Name of proposed development 289 Clinton Ave

Subject: Response to;  
Memorandum - Application Review Report  
Job Location: 285 Clinton St.  
Tax Parcel No. 3-160-143-12  
Owner / Applicant Jaeger

Re: Site Plan Review  
285 Clinton Avenue  
Dobbs Ferry, NY 10522

PROJECT:  
JAEGER RESIDENCE  
285 Clinton Ave,  
Dobbs Ferry, NY 10522

**1 Proposed Site Plan**  
SCALE: N.T.S.  
LED POST 24" MAX LIGHT W DOUBLE HEAD,  
MICRO NITE / STYLE C - TWIN STAFF STAR  
B-K LIGHTING.

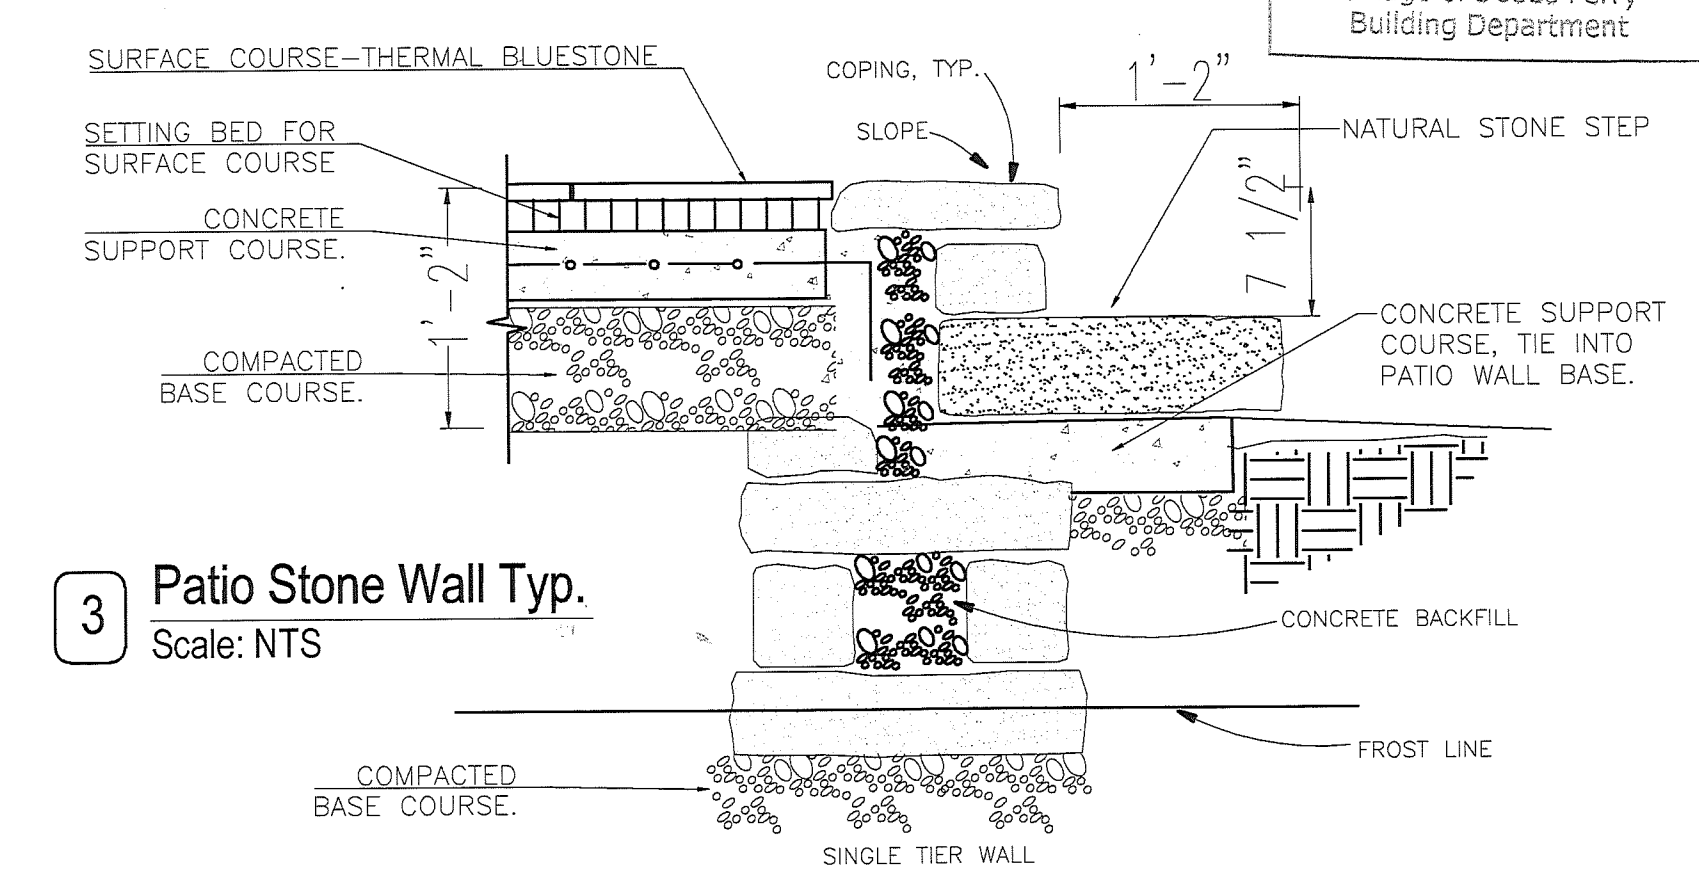
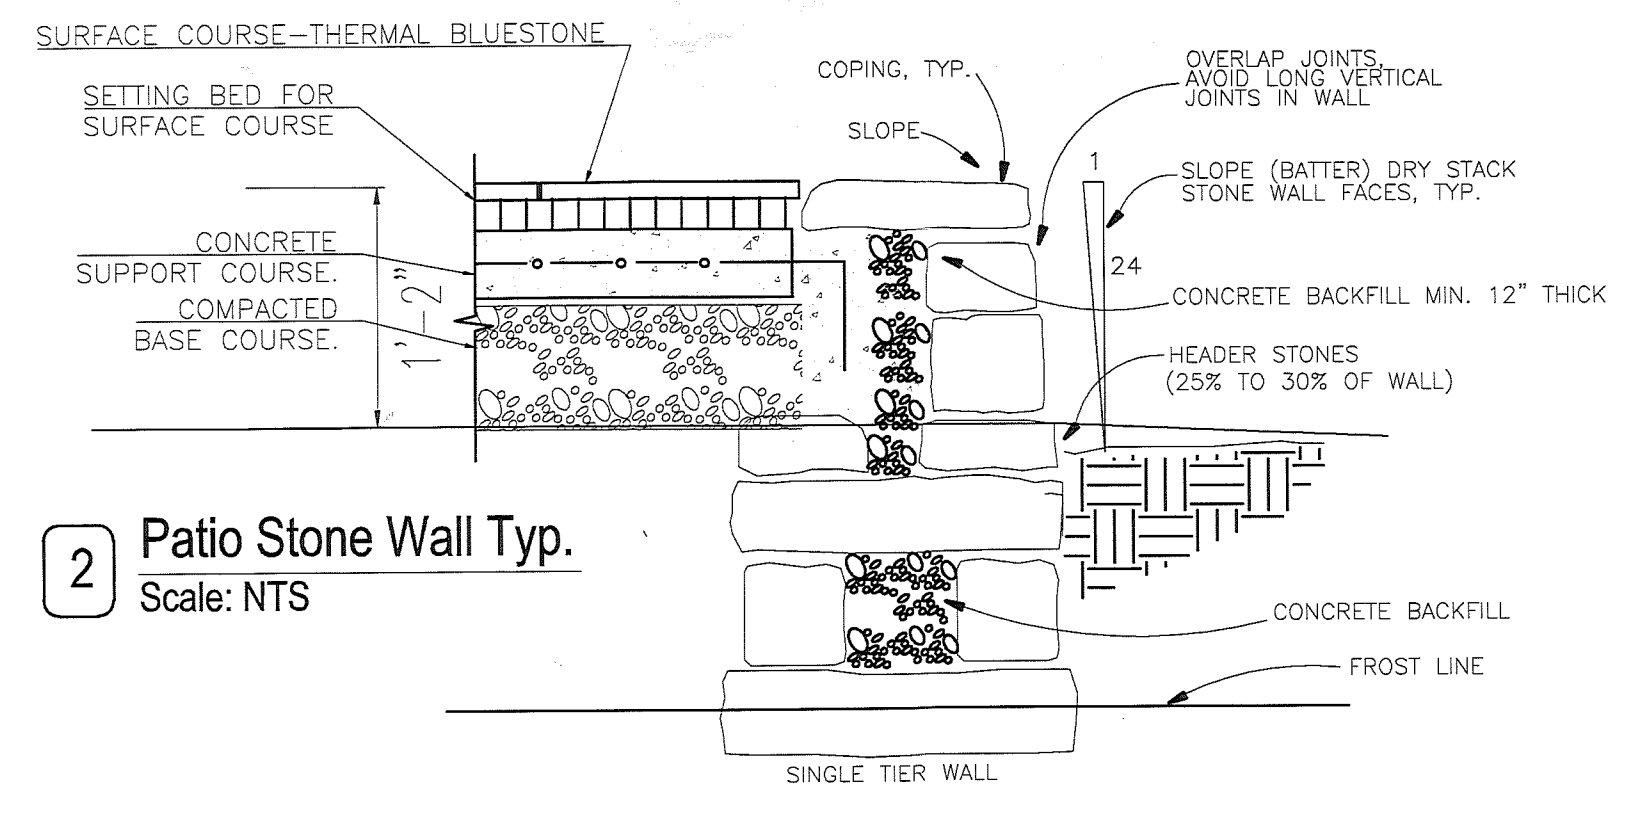
4. We reviewed that the site features line up. The discrepancy is that the A002 Site plan is drawn at a diagrammatic scale and A-003 is drawn to detail the specific proposed construction. The Stone wall surround feature will be flush with the top of the patio creating a stone border around the patio.

2. See C-1, We have fixed the scale as requested.
3. Please see A-002, A-003 – We added some low fixtures that are dark sky compliant lighting around the edge of patios and planting areas.
